SUBJECT: Forwards responses to Questions 361.20 through 361.25 in
 NRC 820426 letter re USGS draft status review. Thirteen oversize
 figures encl. Aperture cards are available in PDR.

Subject: NUCLEAR PROJECT NO. 2
RESPONSES TO NRC QUESTIONS CONTAINED
IN THE USGS DRAFT STATUS REVIEW

Q. 361.20

Q. 361.21

WASHINGTON PUBLIC POWER SUPPLY SYSTEM Nuclear Project No. 2	GEOLOGIC MAP AND CROSS-SECTION CLEMAN MOUNTAIN-UMTANUM RIDGE- MANASTASH RIDGE	Figure 361.21-3
---	---	--------------------

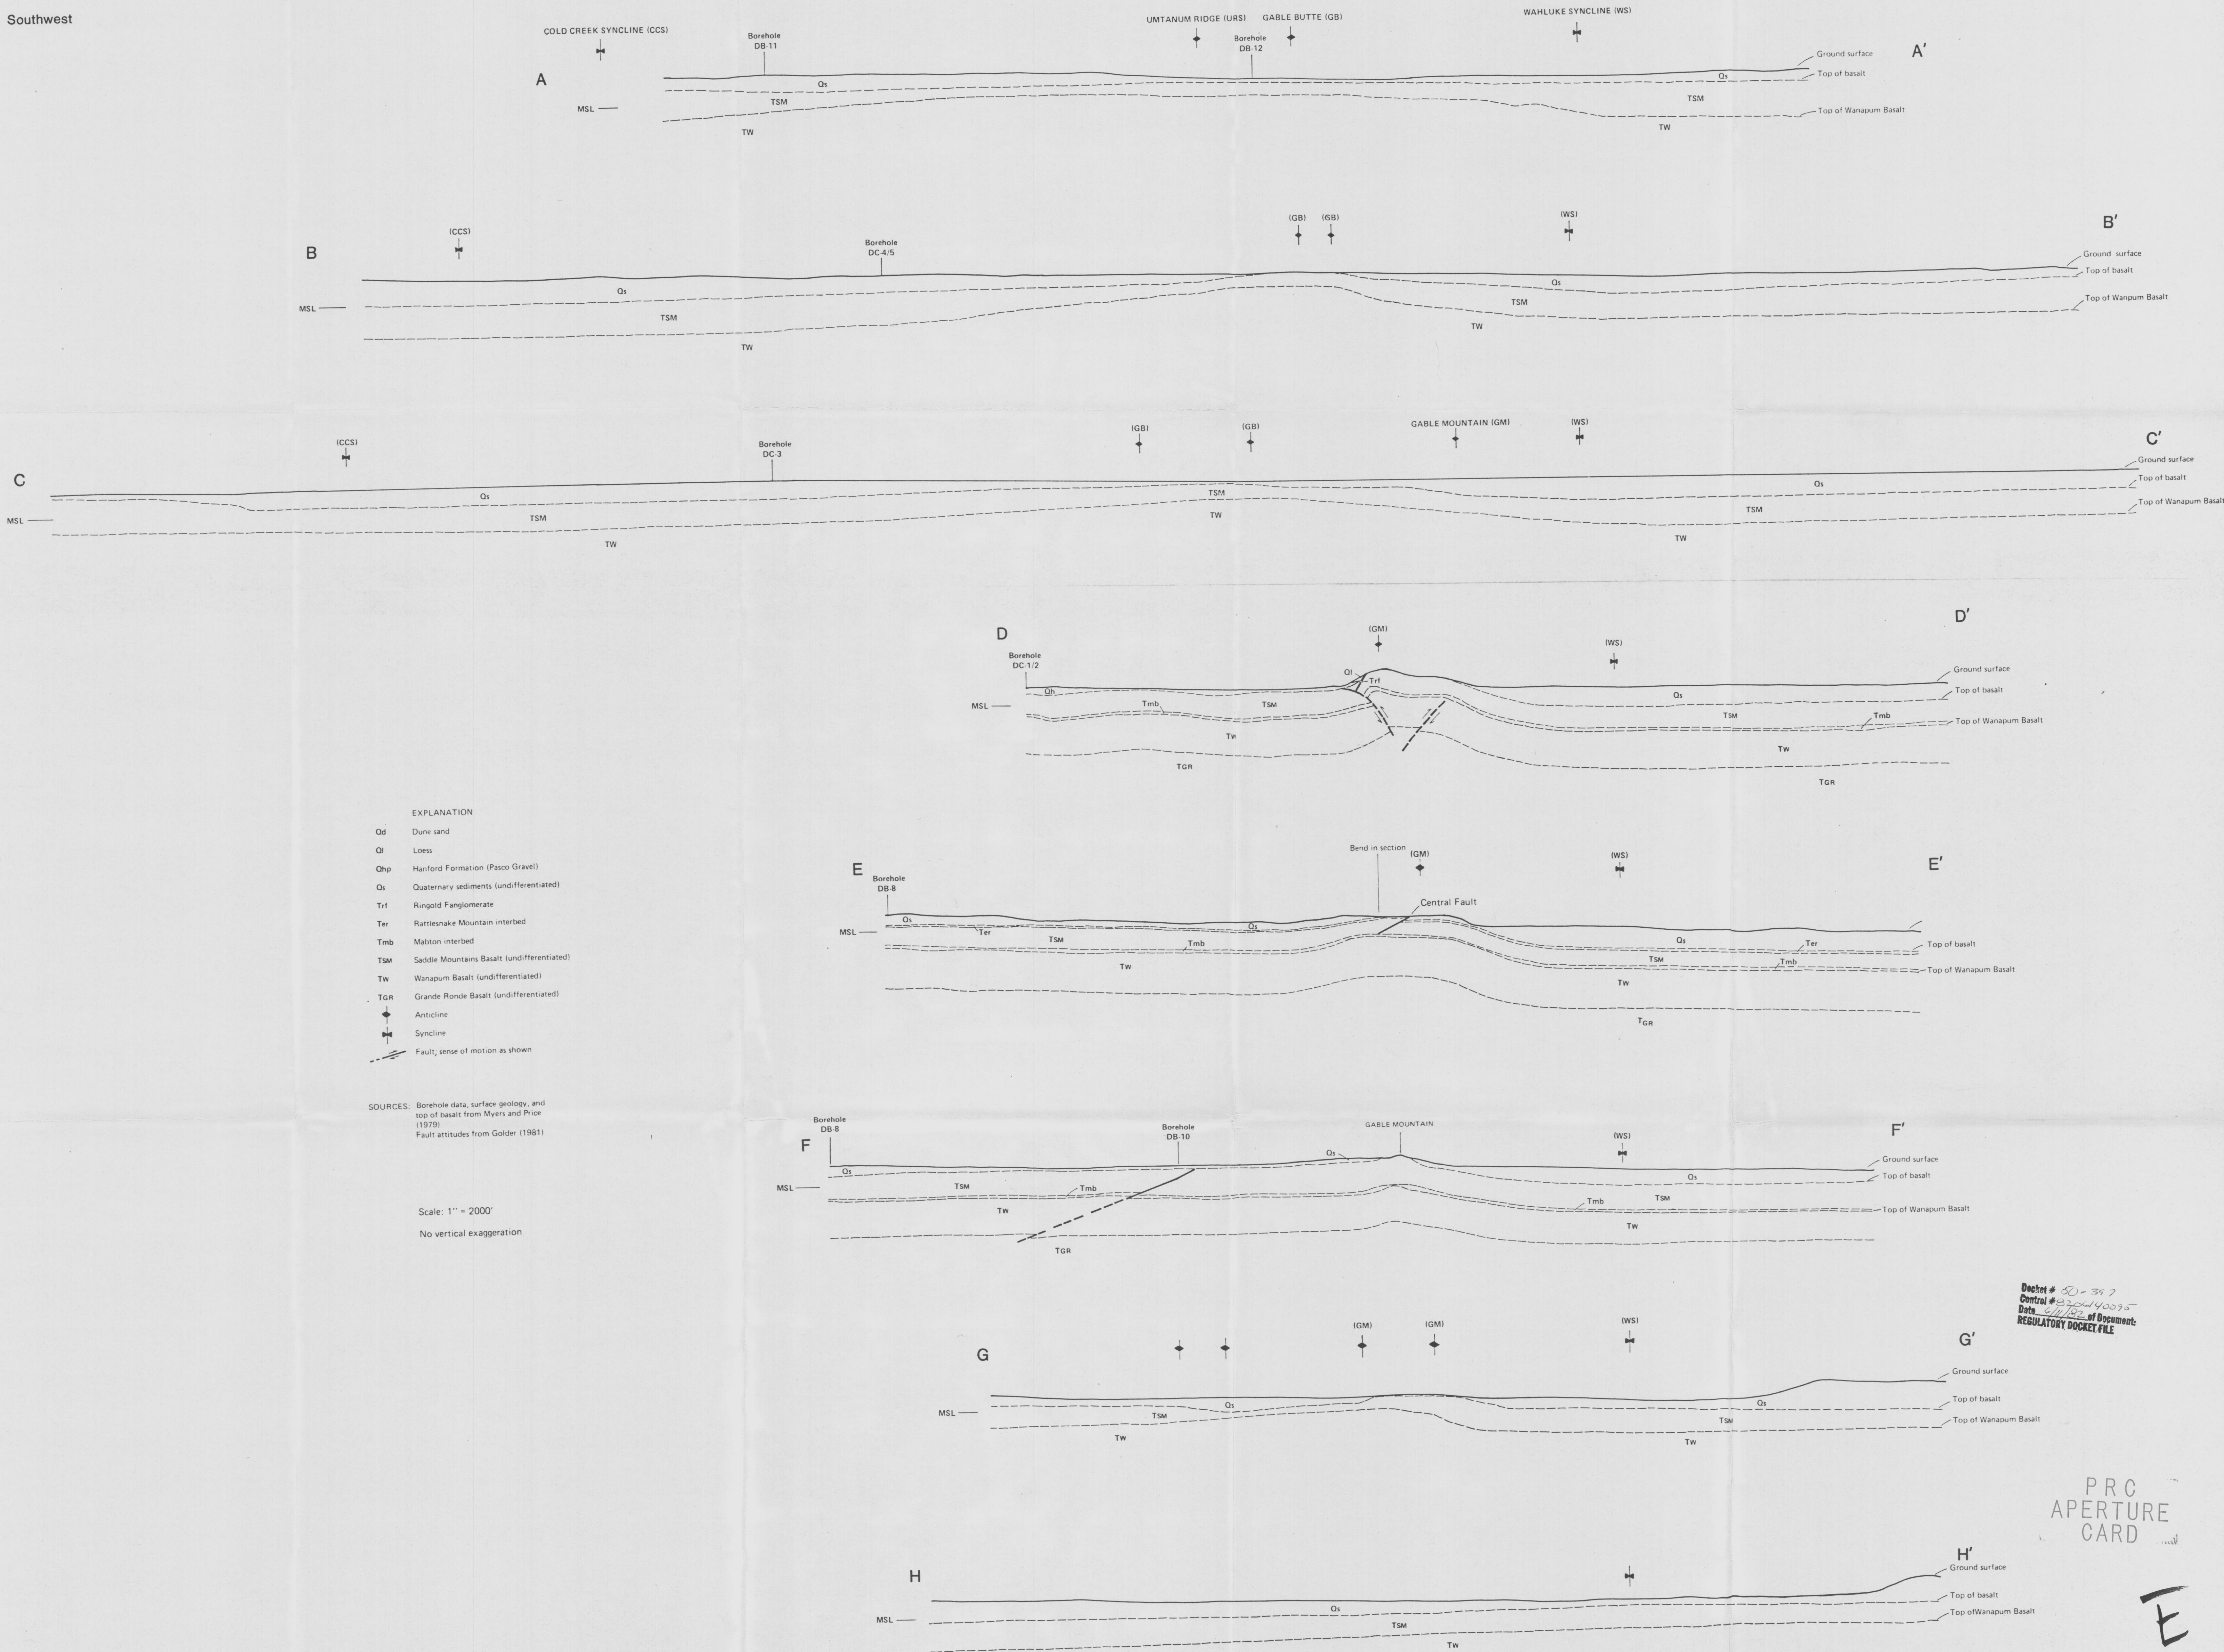
Maps and cross sections of actual examples within the "structural spectrum;" and explanation of how these examples bear on structural interpretations extended into the WNP-2 site area.

Some major plateau folds appear to lack accompanying thrust or reverse faults (e.g. Umtanum anticline north of Cleman Mountain, Figure 361.21-3; the anomalously broad Horse Heaven Hills anticline east of 120° W. longitude; and the Yakima anticline
